A PRELIMINARY PLAN OF

NORTHAMPTON

RE: Northampton POADP
File #86-21-60-68

This is to inform you that the POADP committee has reviewed the captioned plan. Staff analysis is that, the scheme as submitted, is not acceptable until certain issues are resolved. Concerns raised in the review are as follows:

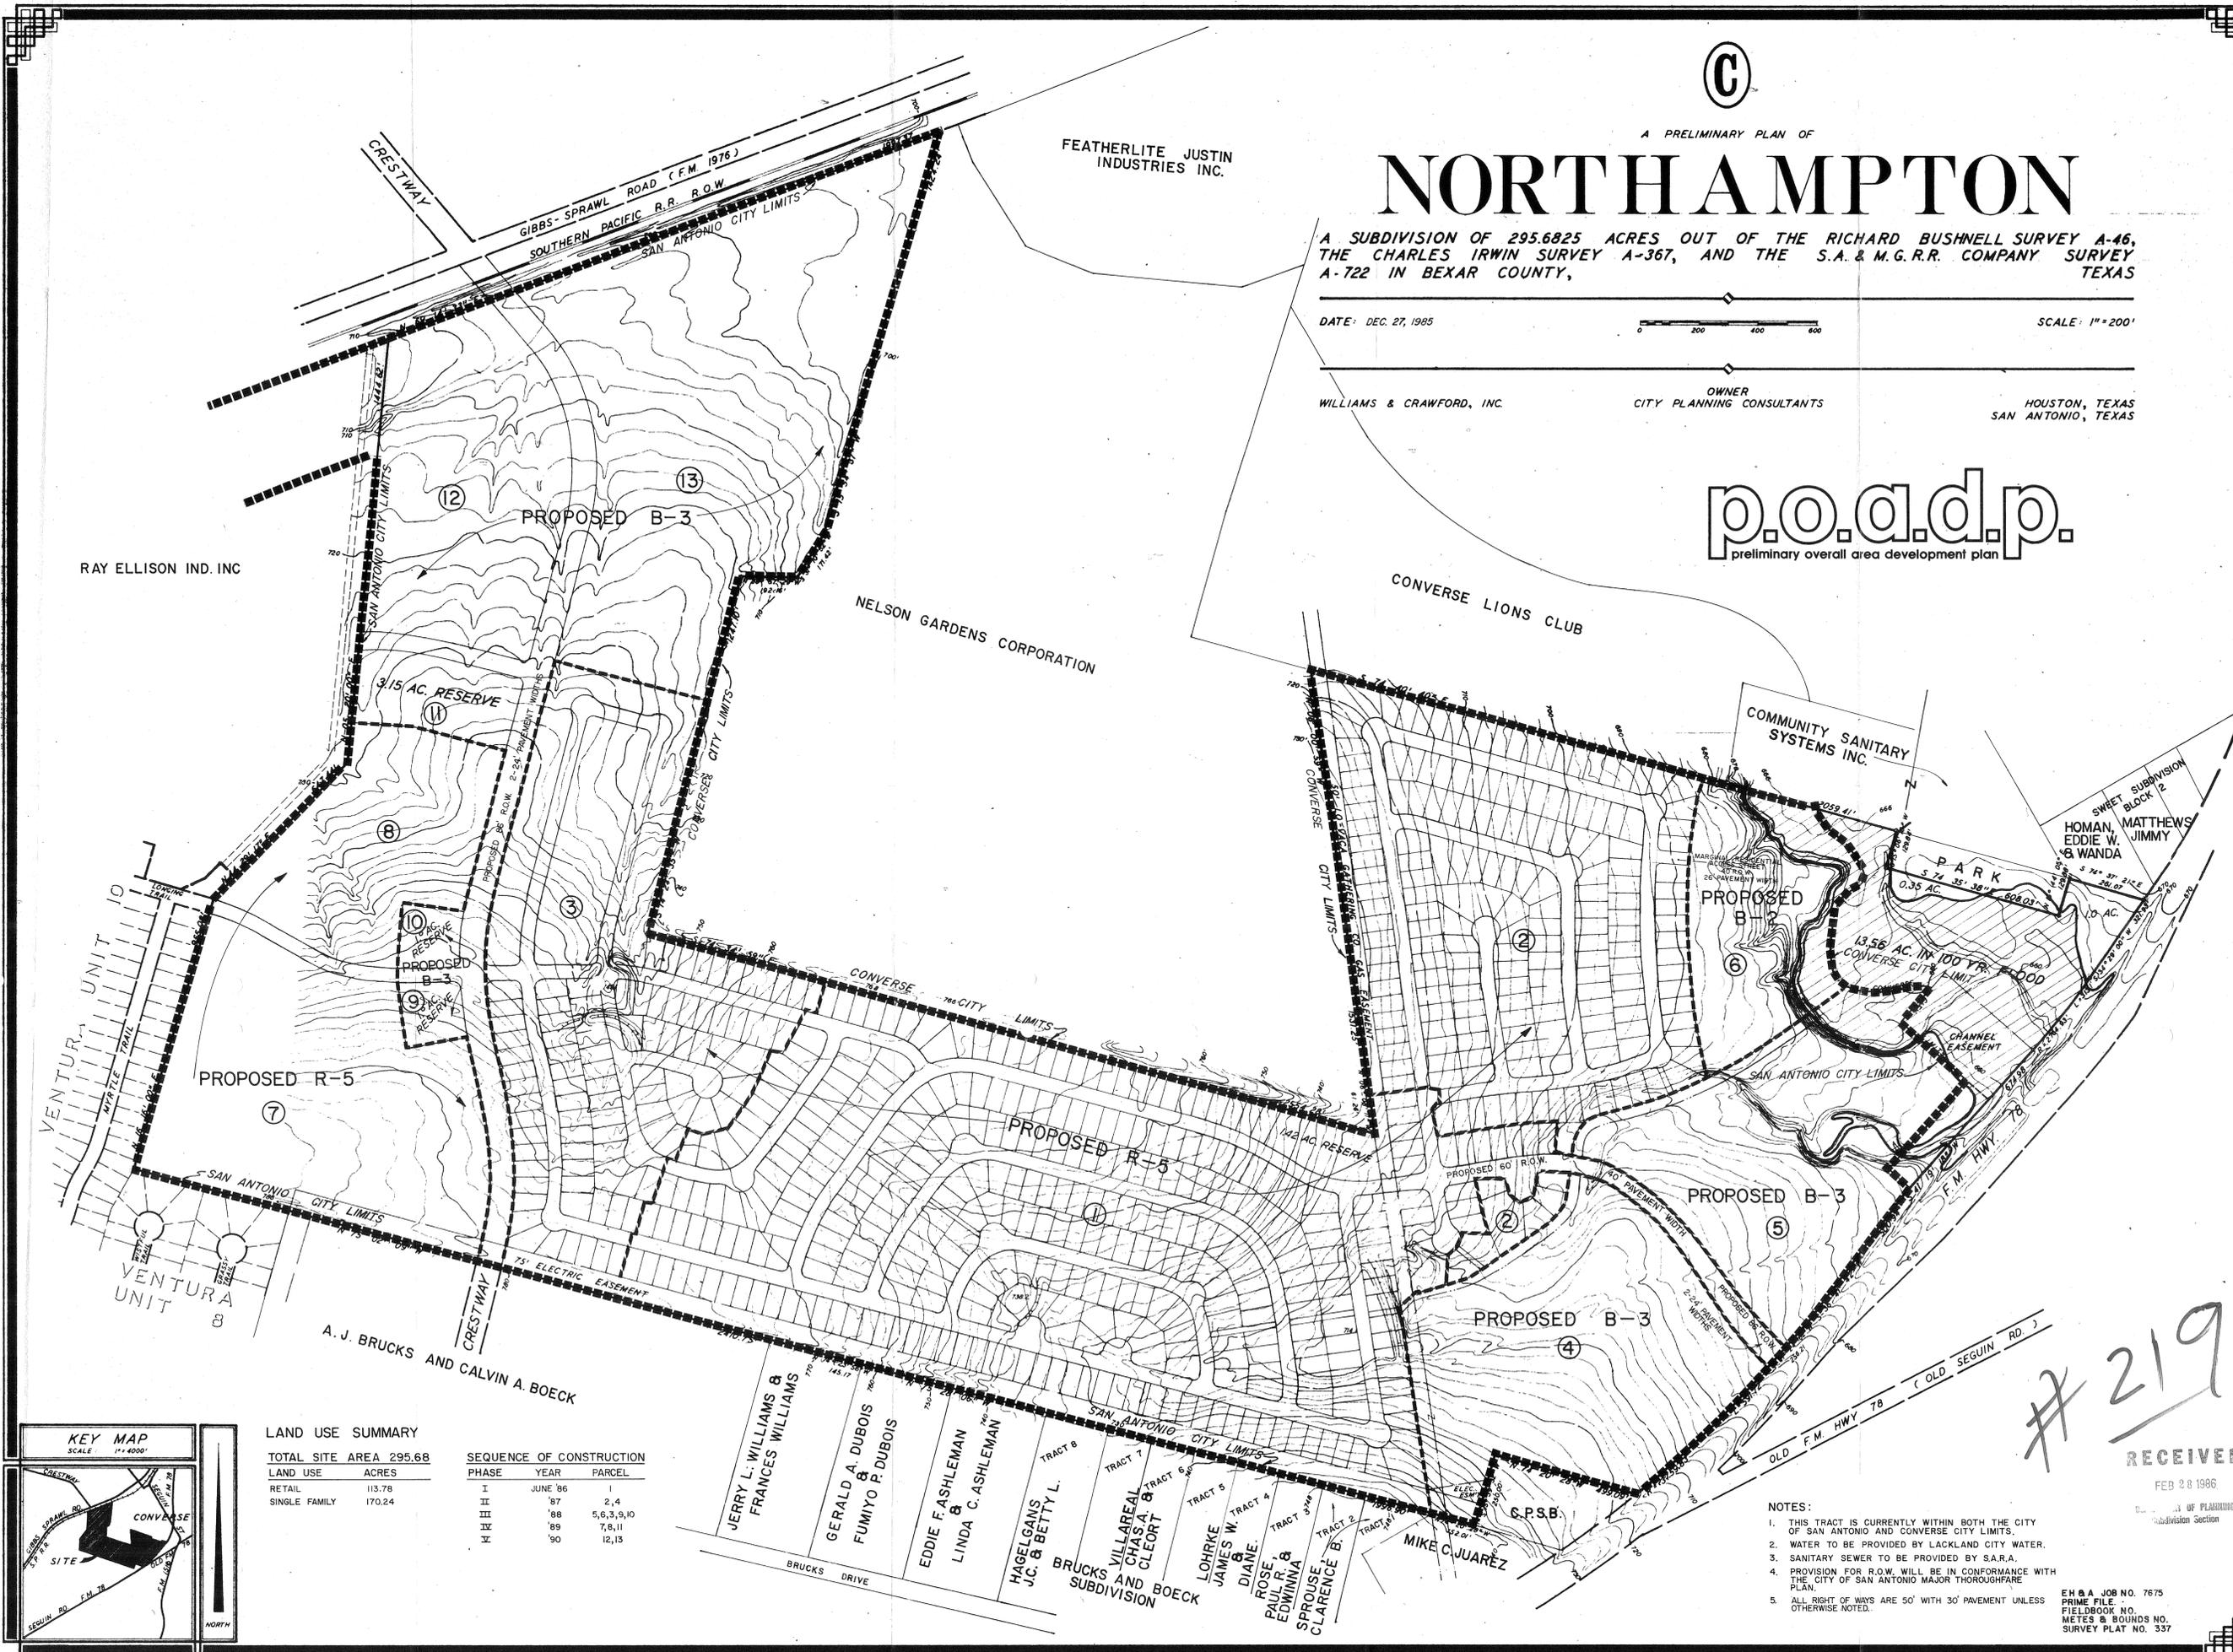
1. The proposed easterly marginal residential access street stub planned in Unit 6.
2. The lack of a local type "B" street (60' ROW - 40' paving) to serve Unit 5 and 6.
3. The proposed 50' ROW between Unit 11 and 12.

To address items one and two, it will be necessary to make provisions for a local type "A" street (50' ROW - 30' paving) and transition into a local type "B" street (60' ROW - 40' paving) to serve Unit 5 and 6 respectively. With regard to item 3, the code calls for a 60' ROW with 40' of paving. These standards are based on the proposed land uses. Attached is a copy of the plan citing the needed modifications.
